UNITED STATES PATENT AND TRADEMARK OFFICE

Office Action Summary	Application No.	Applicant(s)	
	09/934,549	LIN CHENG	
	Examiner	Art Unit	
	Hanh V. Tran	3637

DETAILED ACTION

Application No. 09/934,549
Inventor: Lin Cheng
"Reticle Box Transport Cart"
Replacement Sheet 1 of 1

Fig. 2

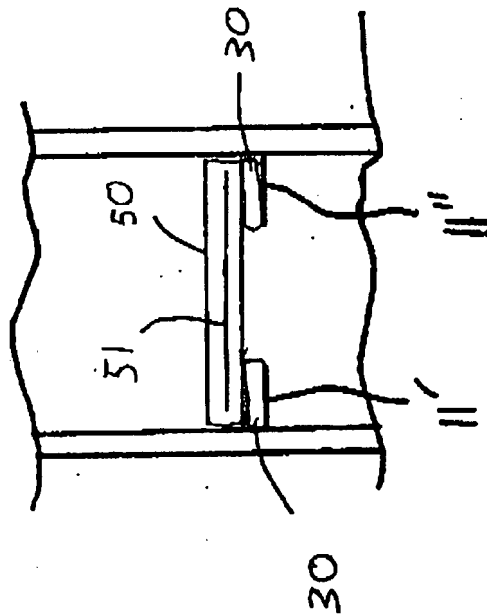
Acceptable!
HNT 5/21/08
